INSTRUCTIONS FOR INSTALLING THE 321474 MODIFICATION KIT  
TO EQUIP EARLY DESIGN KEYBOARD PERFORATORS (LKPE, LKTP) WITH  
IMPROVED CLUTCH TRIP MECHANISM

## SPECIFICATION 50606S

Figure 1

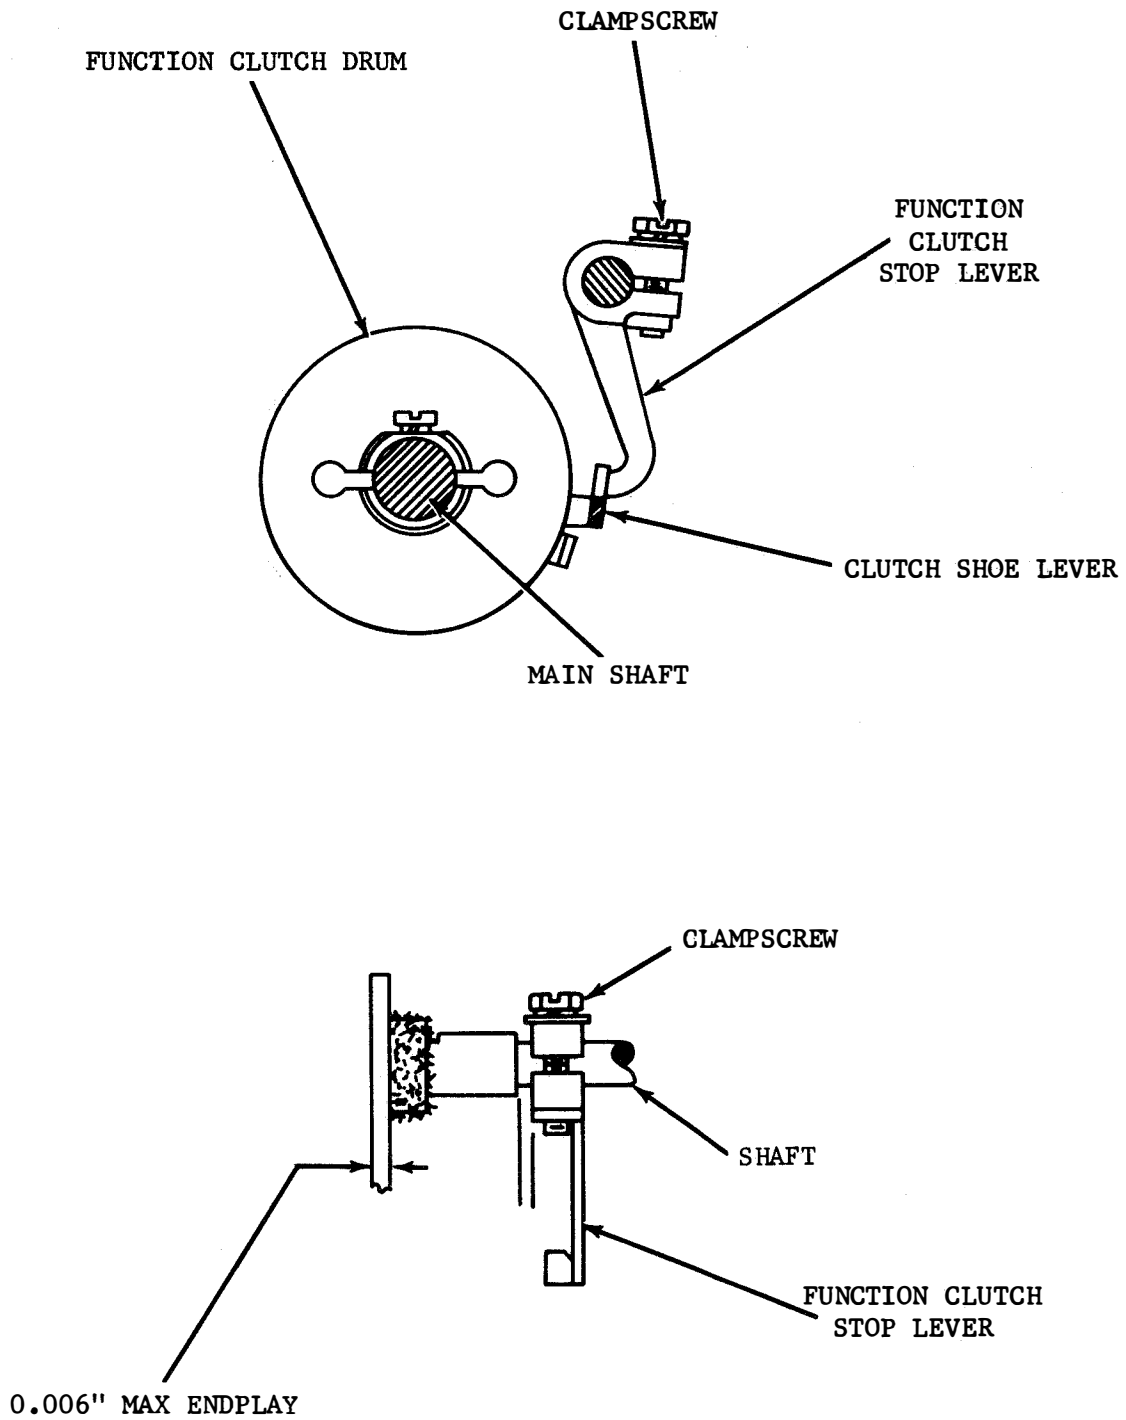
#### 3.02 STOP LEVER ENGAGEMENT (Figure 1)

- (a) Requirement: With release lever resting on top of trip lever extension (Figure 2), the function clutch stop lever should engage the clutch shoe lever by the full thickness of the shoe lever.
- (b) To Adjust: Post the stop lever on its shaft with its clampscrew loosened. Tighten screw.

#### 3.03 ENDPLAY (Figure 1)

- (a) Requirement: Function clutch stop lever should have some to 0.006 inch endplay.
- (b) To Adjust: Position the stop lever on its shaft with its clampscrew loosened. Tighten screw.

Figure 2

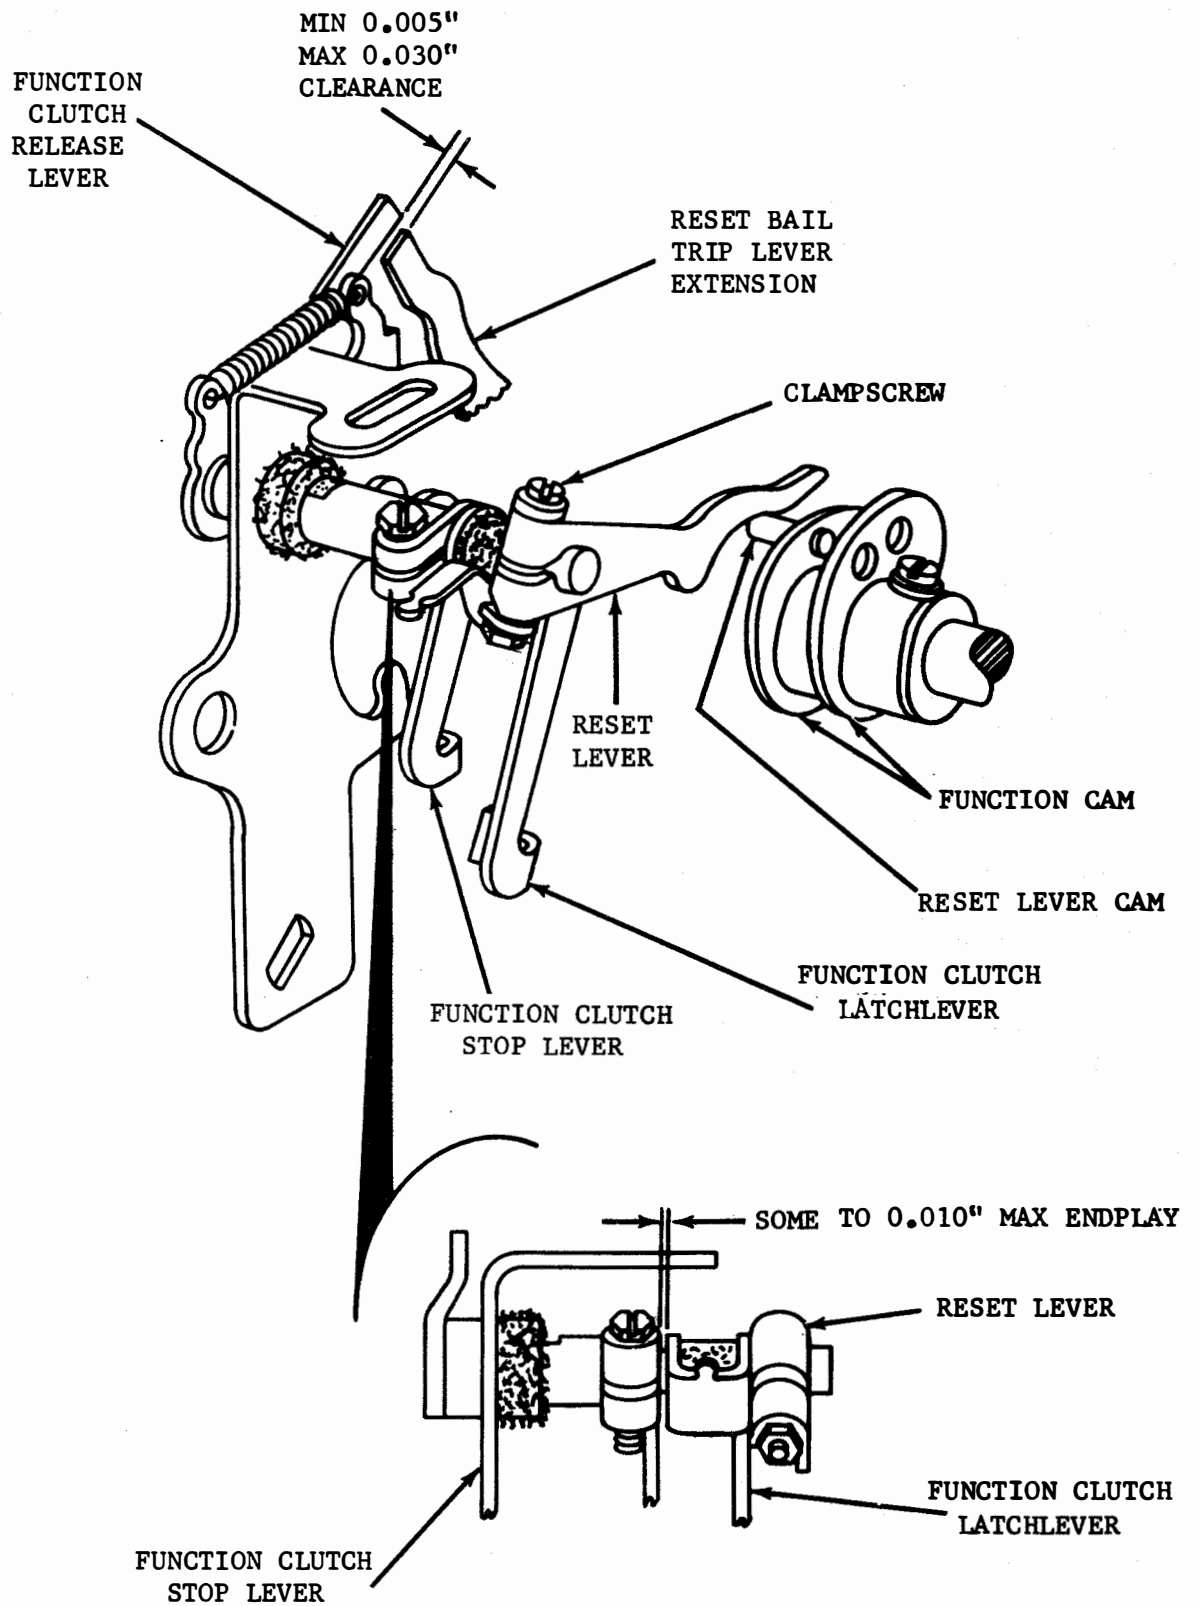
#### 3.04 FUNCTION CLUTCH RESET LEVER AND LATCHLEVER (Figure 2)

- (a) Requirement: Reset lever on the high part of its cam. Clearance gap between the clutch release lever and the trip lever extension should be 0.005 to 0.030 inch with the reset lever riding fully on its cam. There should be some clearance between the reset lever and the function cam and some to 0.010 inch between the stop lever and the function clutch latchlever.
- (b) To Adjust: Loosen clampscrew on reset lever and position on its shaft.

Figure 3

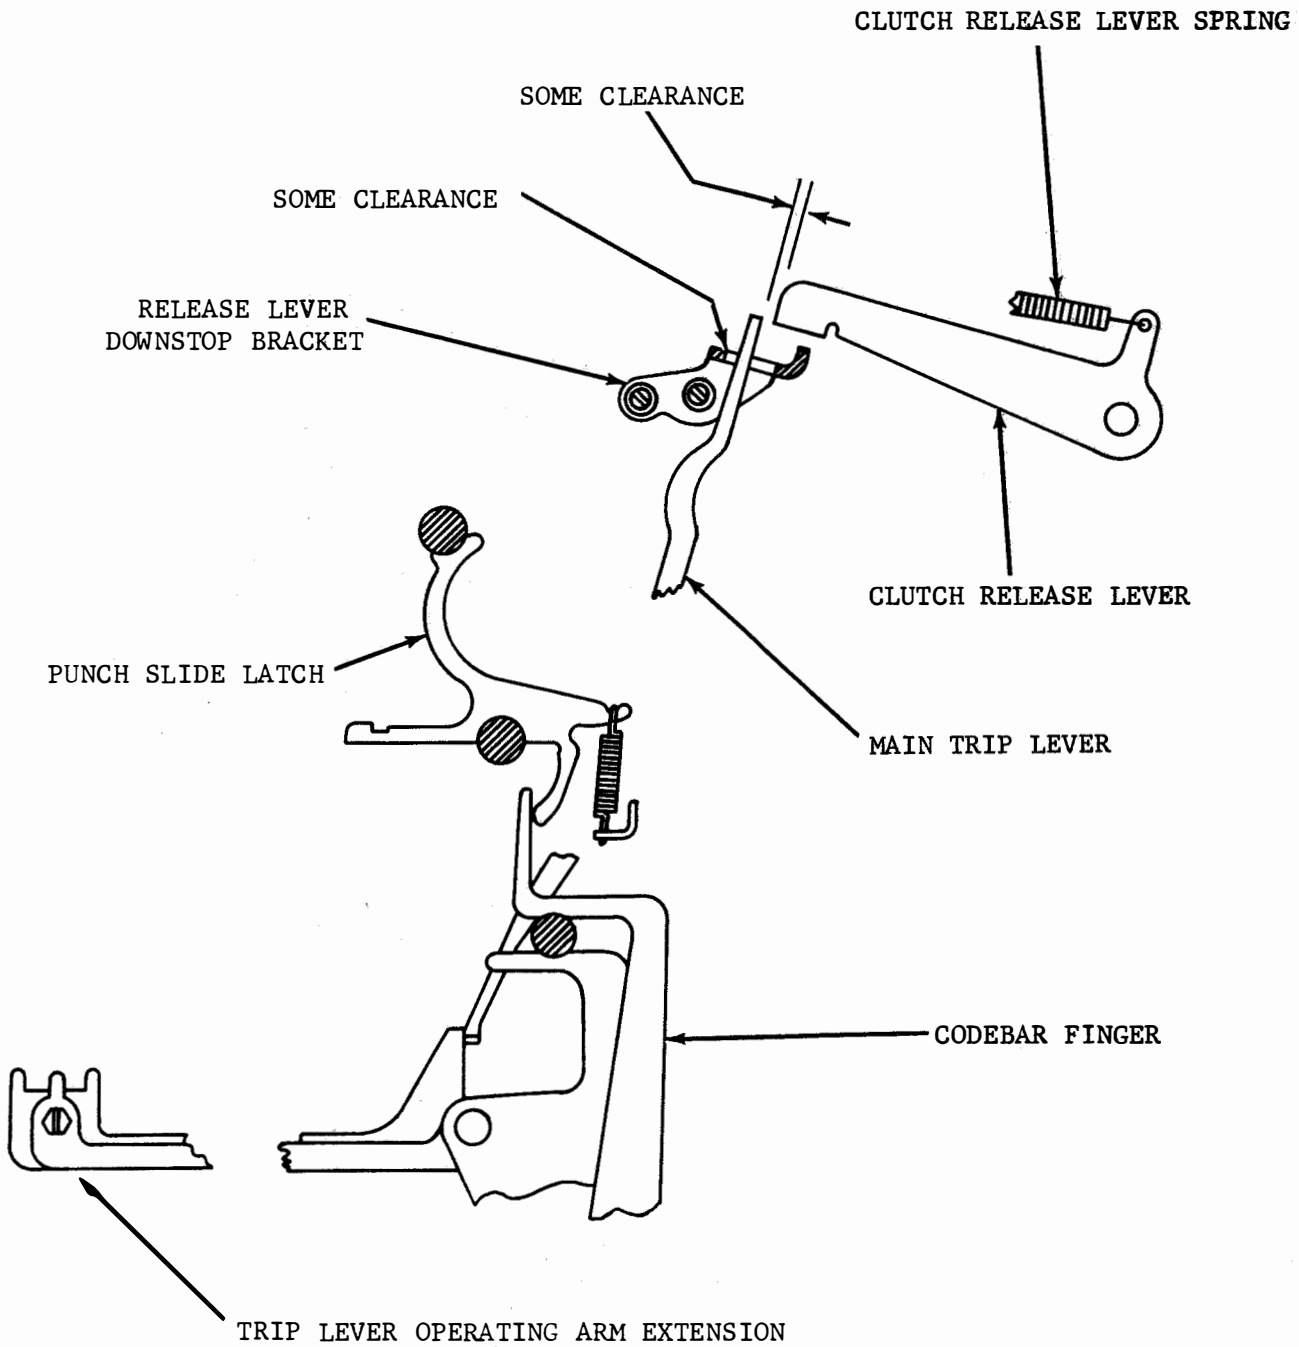
3.05 CLUTCH RELEASE LEVER (Figure 3)

(a) Requirement: Remove the clutch release lever spring. Depress the LETTERS or RUBOUT key. Carefully move the clutch release lever so that its lower edge is just below the top edge of the main trip lever but not far enough to release the clutch nor to disengage the trip lever release lug from the trip lever operating arm. There should be some clearance between the end of the clutch release lever and the main trip lever. The main trip lever should have some overtravel.

(b) To adjust: Loosen the screw at the trip lever operating arm adjustment extension and adjust to meet requirement. Tighten the screw. Check the adjustment by manually depressing the clutch release lever to release the clutch. Rotate the shaft through one cycle. Check the adjustment and refine if necessary.

Figure 4

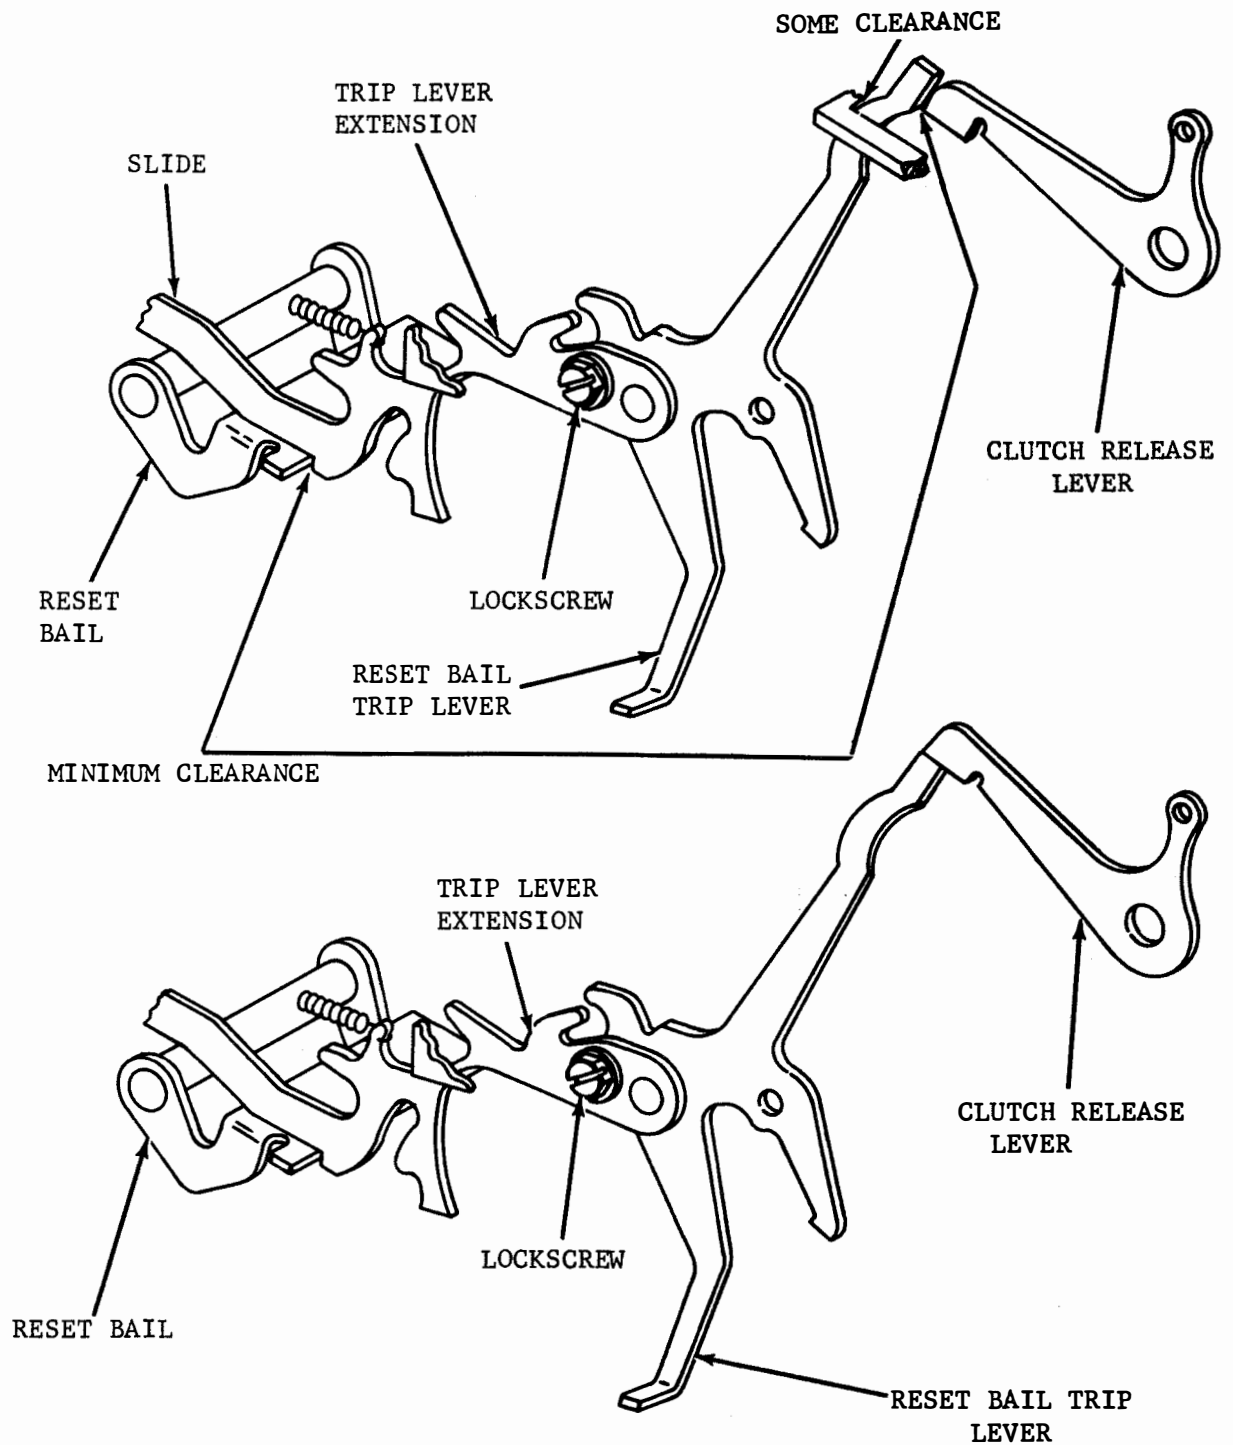
3.06 RESET BAIL TRIP LEVER ADJUSTMENT (Figure 4)

(a) Requirement: With BLANK combination selected, manually rotate reset bail trip lever. The punch slide reset bail should trip before the function clutch is tripped.

(b) Requirement: With the function clutches disengaged and latched, the punch slide reset bail should fully engage the punch slide latching surface. Take up the play in the parts so that engagement is minimum.

(c) To adjust: With the trip extension lock screw friction tight and LETTERS combination selected, position reset bail against punch slides. Take up play between reset bail and the trip lever in a counterclockwise direction. Position the trip lever by means of its pry point. Tighten the lock screw. Recheck blank adjustment above and refine if necessary.

Figure 5

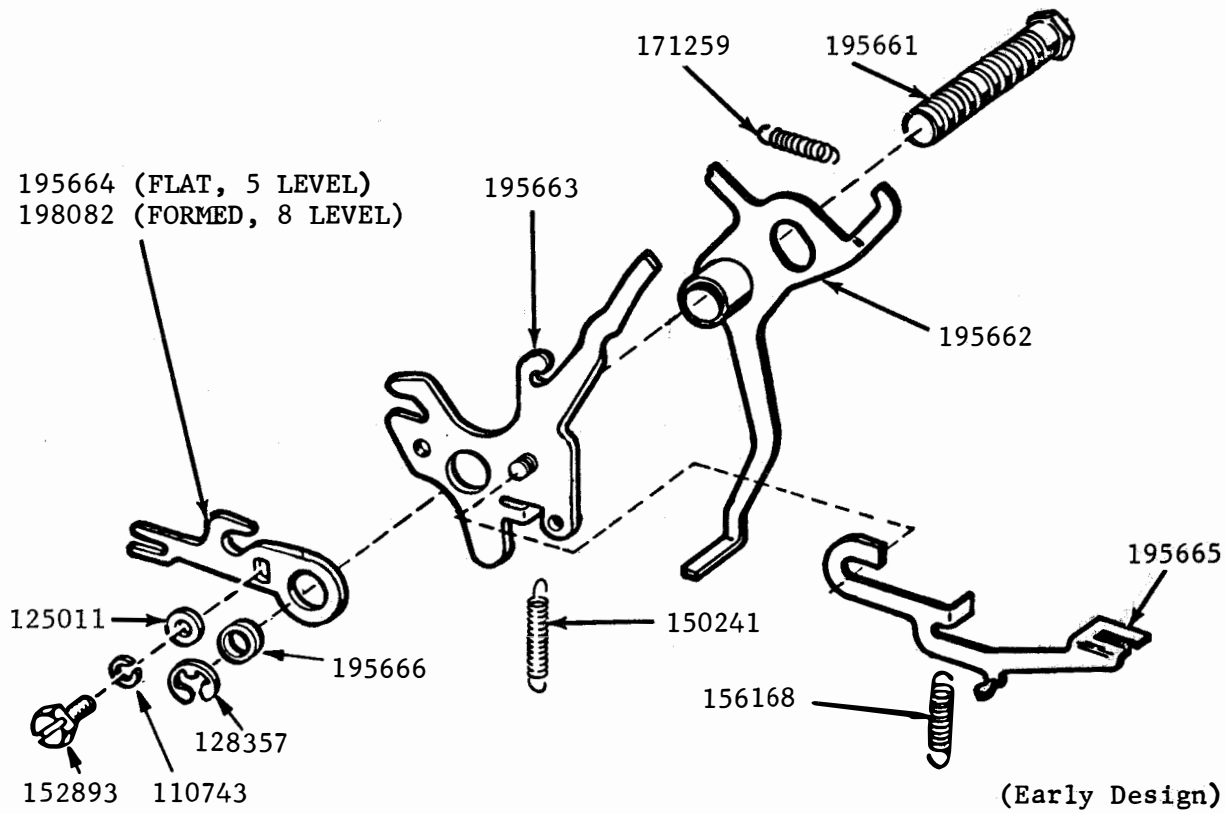
- 2.01 Remove the following parts (Figure 5).
- 152893 Screw (Retain)
  - 110743 Lockwasher (Retain)
  - 125011 Flat Washer (Retain)
  - 128357 Retainer Ring (Discard)
  - 195666 Spacer (Discard)
  - 195664 or 198082 Slide Trip Lever (Discard)
  - 150241 Spring (Retain)
  - 156168 Spring (Discard)
  - 195665 Guide Lever (Discard)
  - 195663 Trip Lever (Discard)
  - 171259 Spring (Discard)
  - 195662 Lever (Discard)
  - 195661 Guide Post (Discard)
- 2.02 Replace the parts removed in 2.01 with the following parts (Figure 6).
- 170202 Guide Post - Part of 321474 Modification Kit
  - 156267 Main Trip Lever - Part of 321474 Modification Kit
  - 150241 Spring
  - 159430 or 170207 Slide Trip Lever - Part of 321474 Modification Kit
  - 119652 Retainer Ring - Part of 321474 Modification Kit
  - 125011 Flat Washer
  - 110743 Lockwasher
  - 152893 Screw

Figure 7

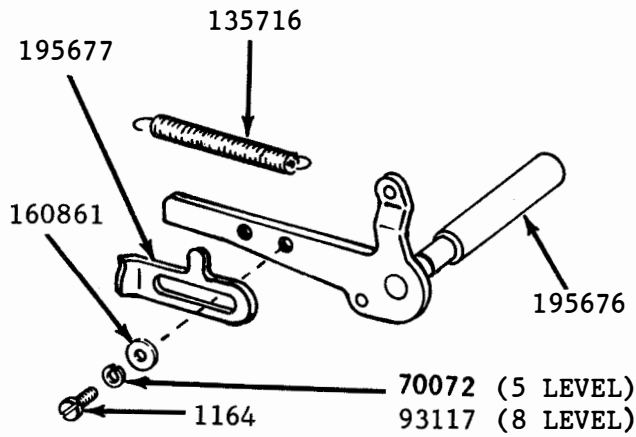
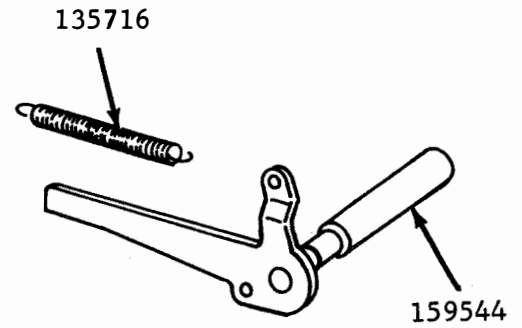
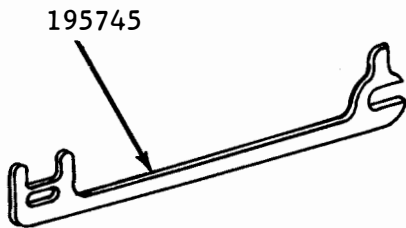
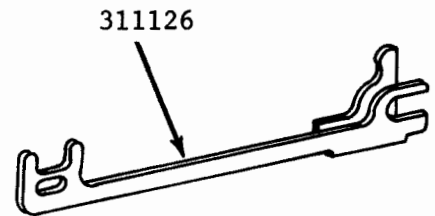
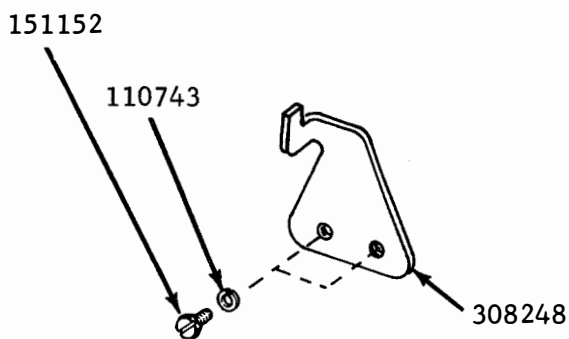
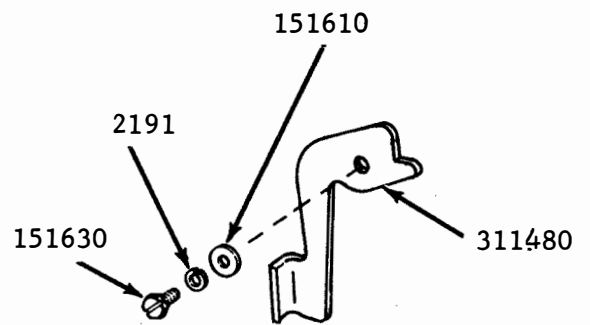
- 2.03 Remove and discard the 1164 screw, 70072 or 93117 lockwasher, 160861 flat washer, 195677 stop plate, and 95676 clutch release. Remove and retain the 135716 spring. Replace the above parts with 159544 clutch release and re-install the 135716 spring (Figure 7).
- 2.04 Remove the 195745 extension and replace with 311126 extension (Figure 7).
- 2.05 If an LKPE800 unit is being updated, remove and discard the two 151152 screws, two 110743 lockwashers, and one 308248 lever guide (Figure 7).
- 2.06 If an LKTP800 unit is being updated, remove and discard 151630 screw, 2191 lockwasher, 151610 flat washer, and 311480 guide lever (Figure 7).
